# Land at Broadfields, Wivenhoe, Colchester

Response to Comments from CBC.

## Response Comments from CBC

# Local Context Photos

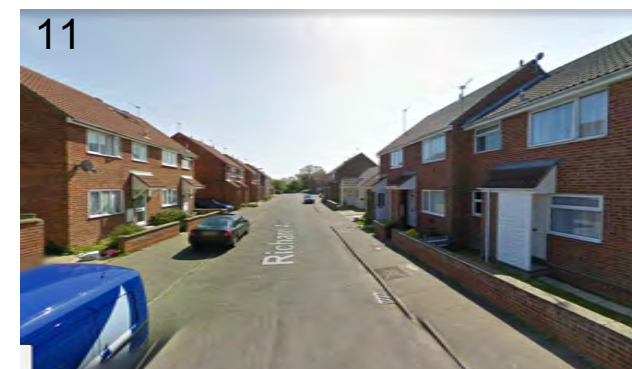
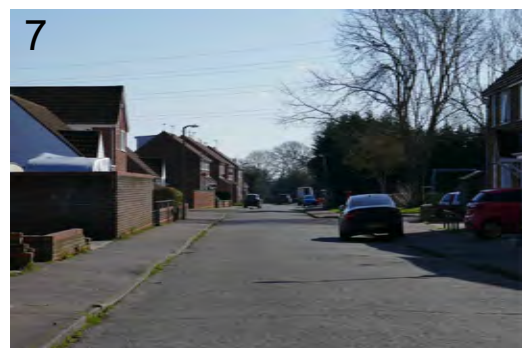
CBC comment - Building Design

'the design of the buildings must reinforce the local distinctiveness of the area / to create a distinct sense of place'.

The images below are from the development to the west of the proposed site, showing limited distinct or repetitive features, particularly those which are not considered to be fully reflective of the traditional Essex vernacular.

## Updated NPPF Tree lined Roads

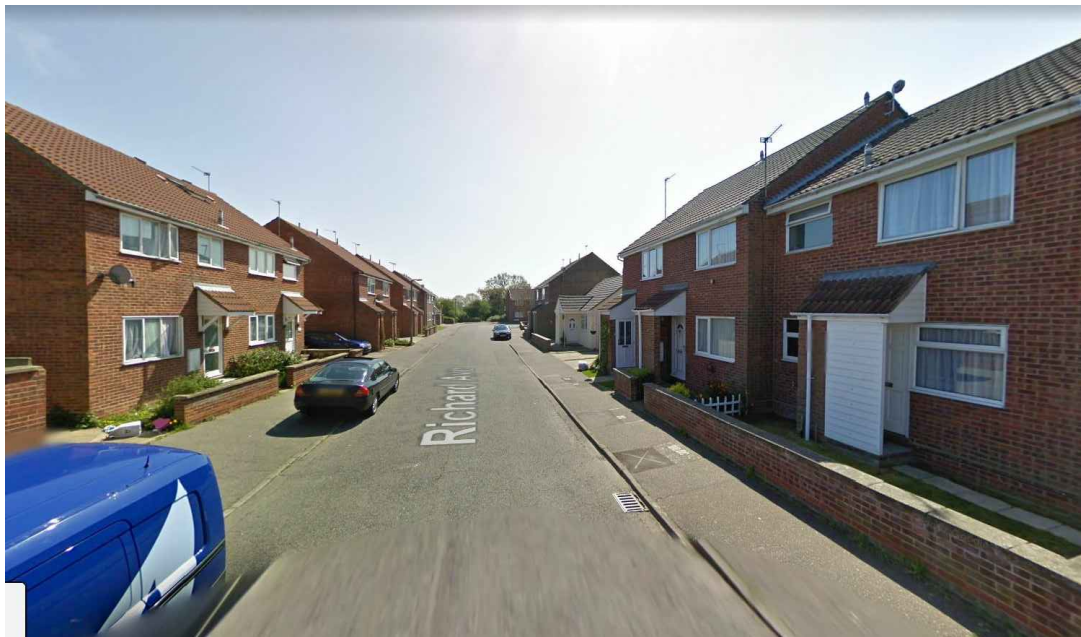
The updated NPPF also specifically acknowledges the important contribution that trees make to the character and quality of urban environments and that trees can also help mitigate and adapt to climate change. The Guide requires that new streets are tree-lined and that opportunities are taken to incorporate trees elsewhere in developments. It is important to ensure that the right trees are planted in the right places and that appropriate measures are in place to secure the long-term maintenance of newly-planted trees and that existing trees are retained wherever possible. To enable an informed decision to be made as to whether the right trees are being planted in the right place, the LPA will require details of the proposed tree species. The layout will also need to be amended to reflect the requirement that new streets are lined with trees.

The approach road leading into site is not tree lined as the image below, a full response on the NPPF is set out in 'savill's covering letter.

An extract from the existing proposal indicates trees along the main street, with consideration of sight splays and the overhead powerline easement.

## Bungalow / Fire Access

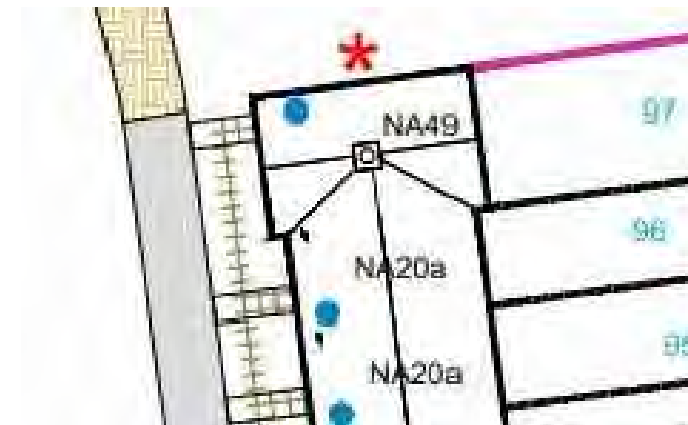
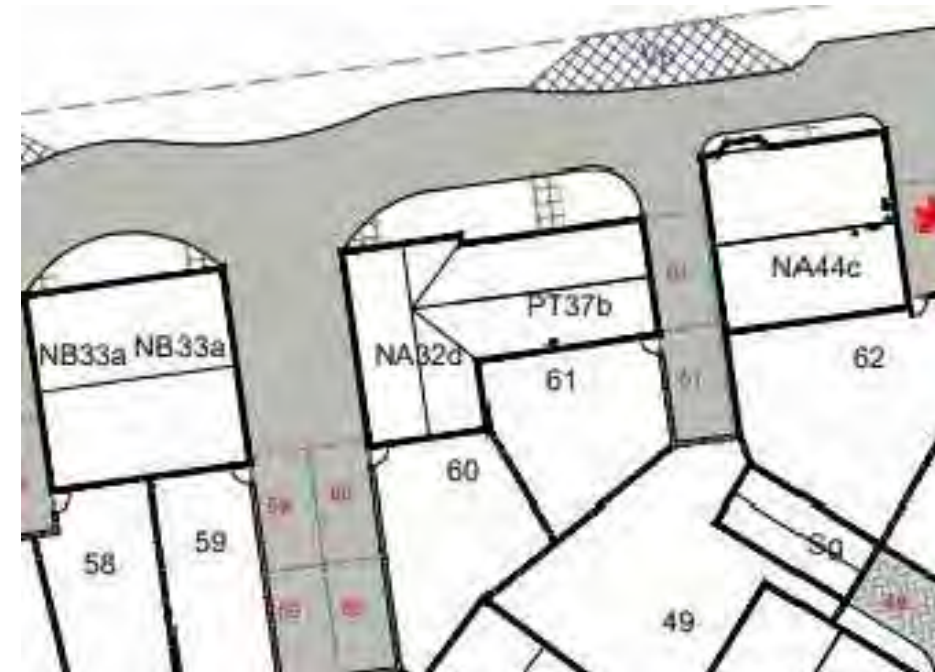
The bungalow is at odds with the rest of the development and immediately adjacent built form. The tarmac area to the front of the bungalow appears unnecessary.

The bungalow was a requirement to meet the need for a wheel chair accessible unit, the local development has several bungalows randomly situated within the street. The site allocation allows for the provision of a bungalow.

The tarmac driveway was necessary to accommodate the Fire tender reaching all plots to meet the NHBC requirements.

# Materials

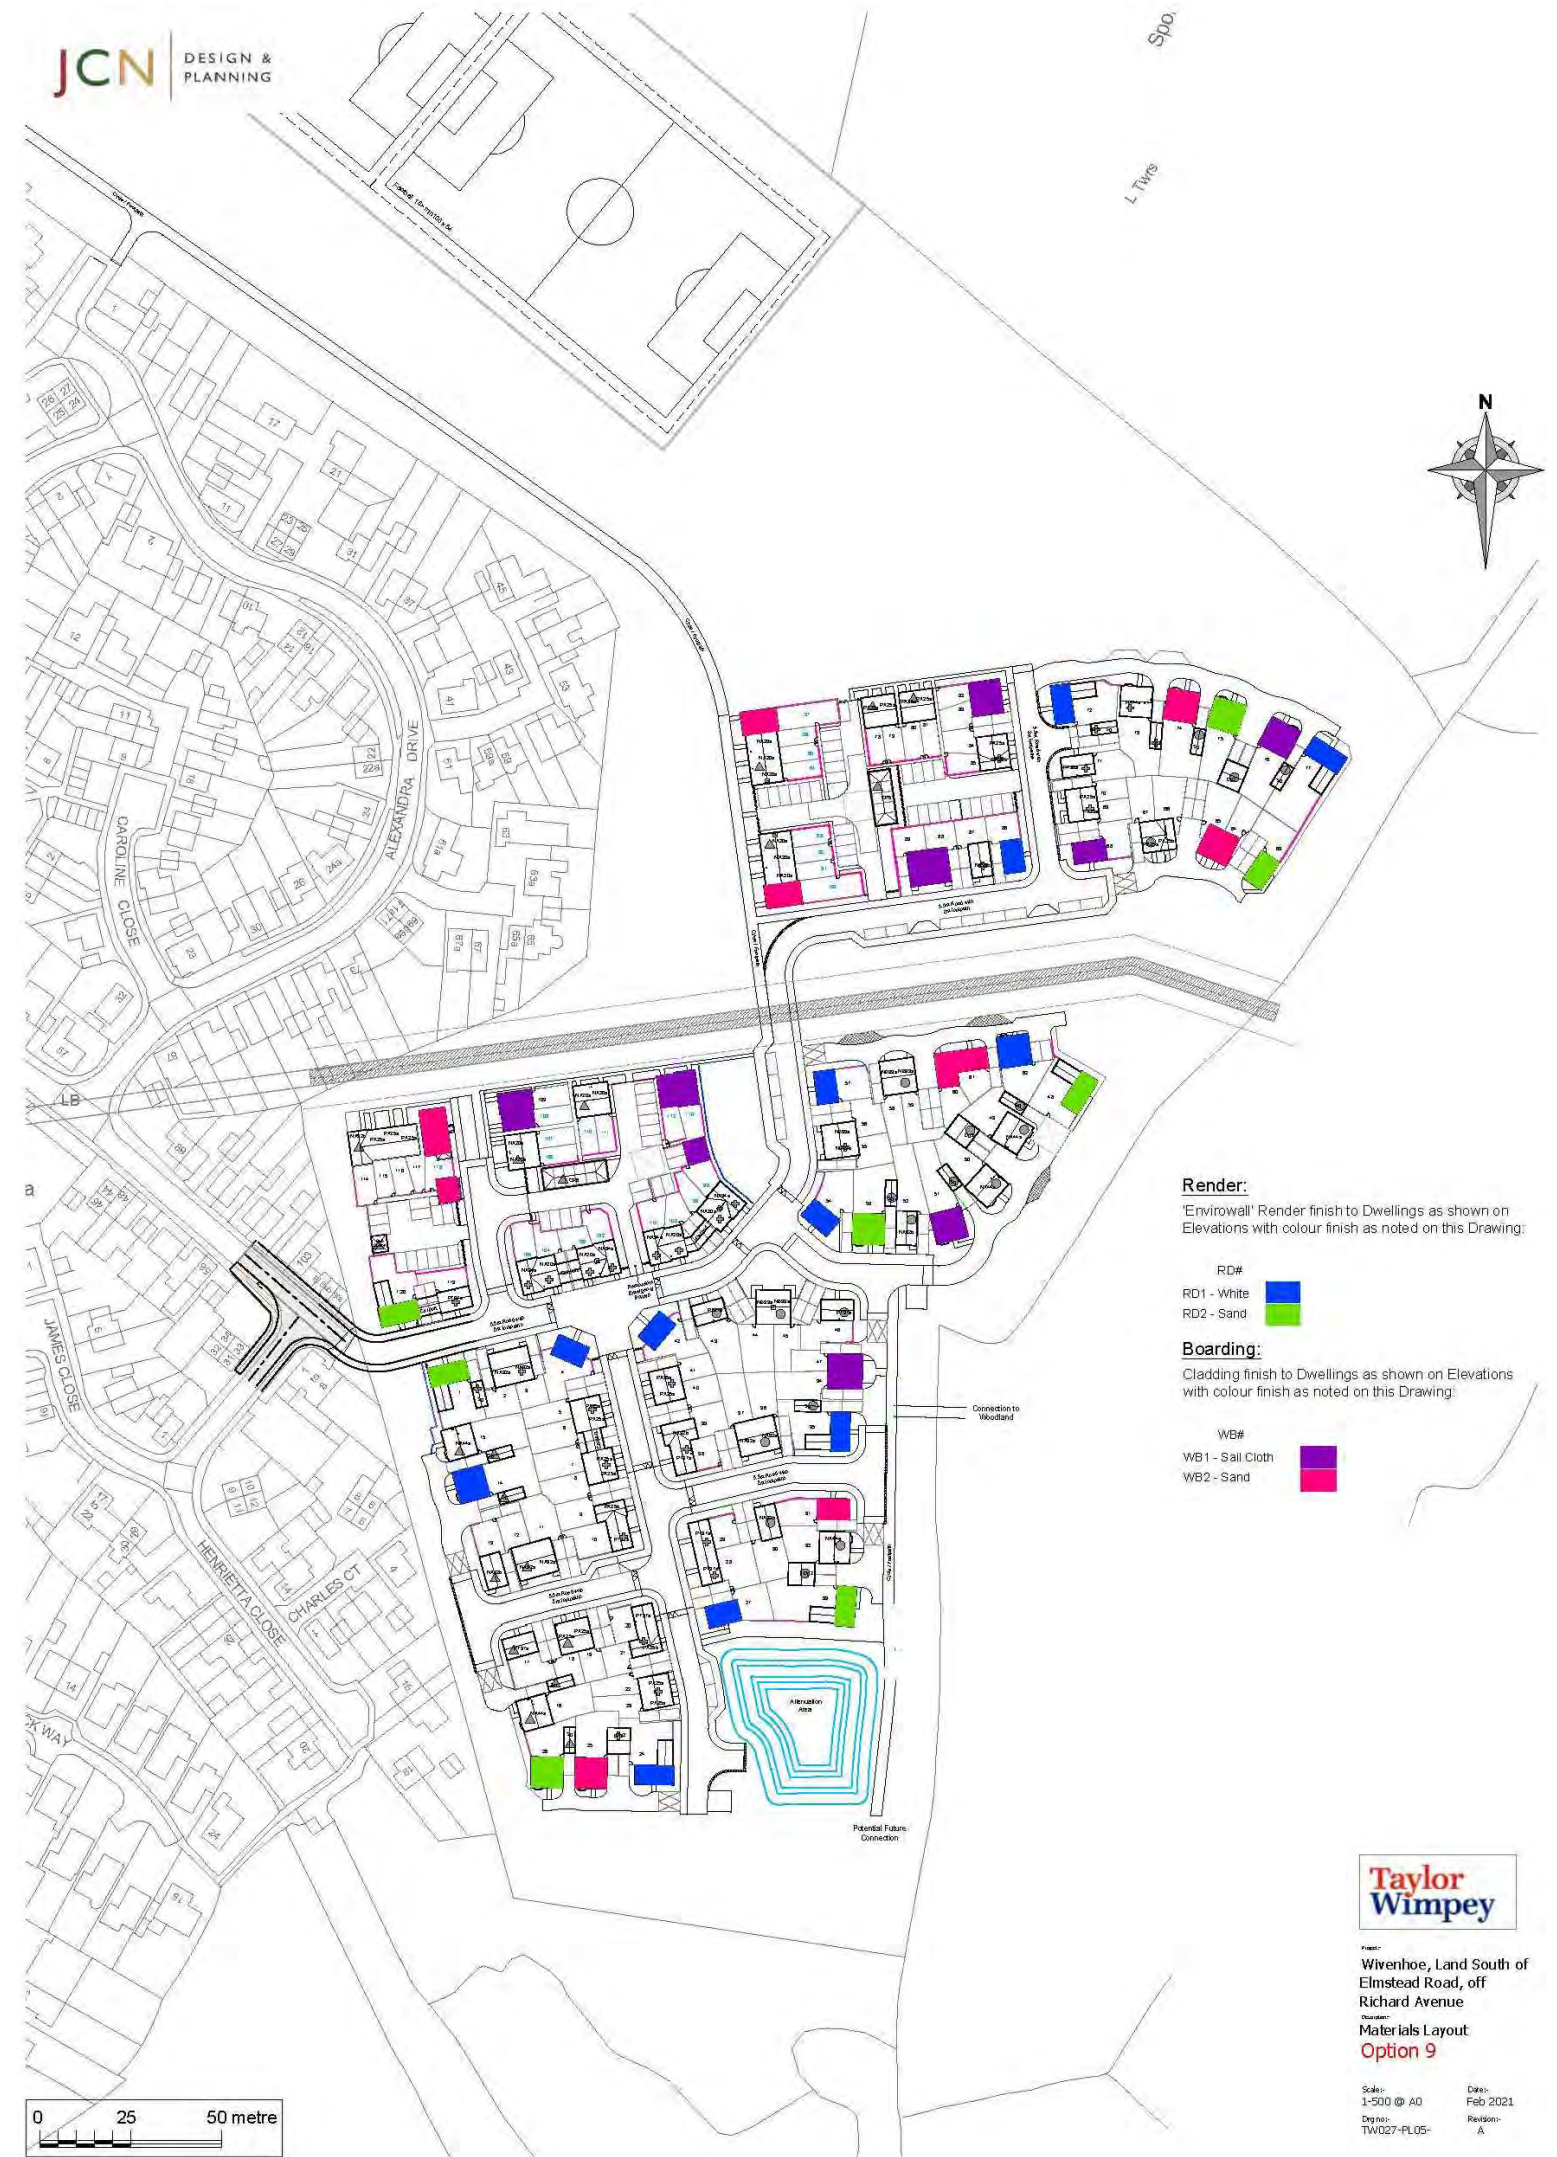
The logical application of materials and appropriate detailing should contribute to the definition of distinct character areas and the identity of the site. Focal/nodal buildings should be included to enhance legibility within the site. Plans should specify which colour render/weatherboarding is to be utilised on specific plots.

An additional drawing prepared to help distinguish what plots will have render or weather boarding with a specified colour . The brick fabric materials are located to distinguish character zones, woodland edge, central and the developed edge, the placing of cladding material on specific plots gives legibility.

## Non-generic Side elevations

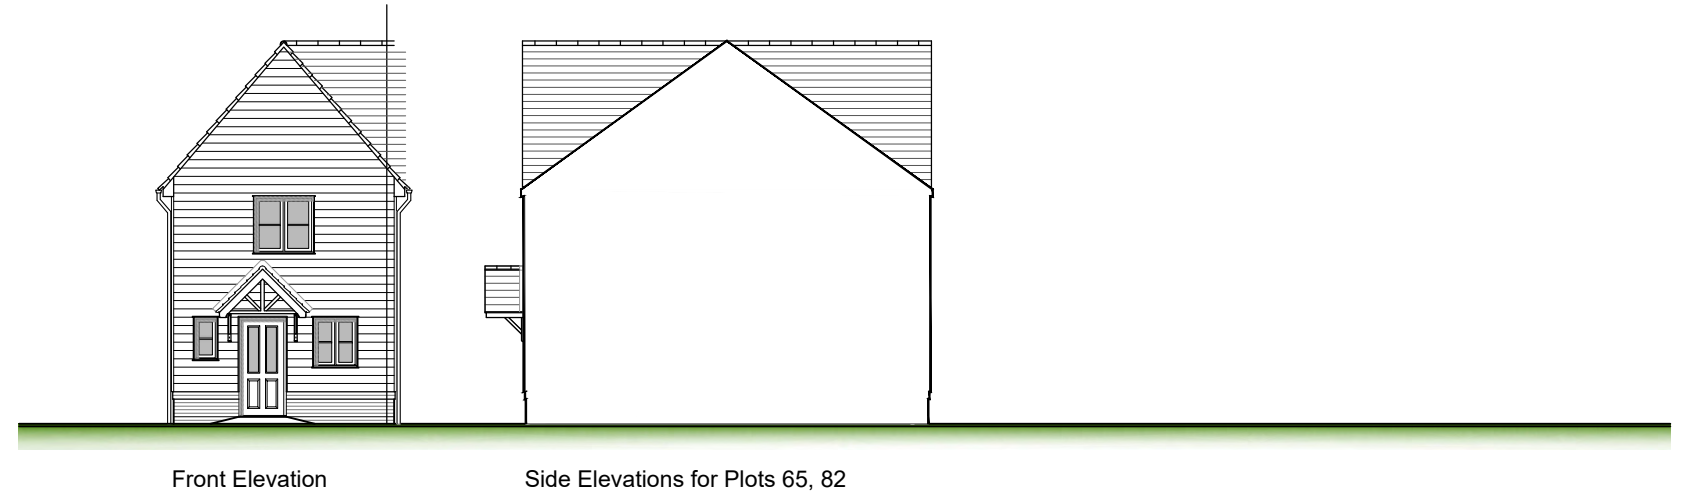
Plans for units NA32d and PA25d, misrepresents the attached unit and require articulation between units.

Plans for unit PA25b has a varying relationship with attached units and requires articulation between units (21, 66, 85).

Drawings have been revised to show correct elevation for attached units, PA25b units are attached to similar house types with mirrored floor plans as PA25d above.
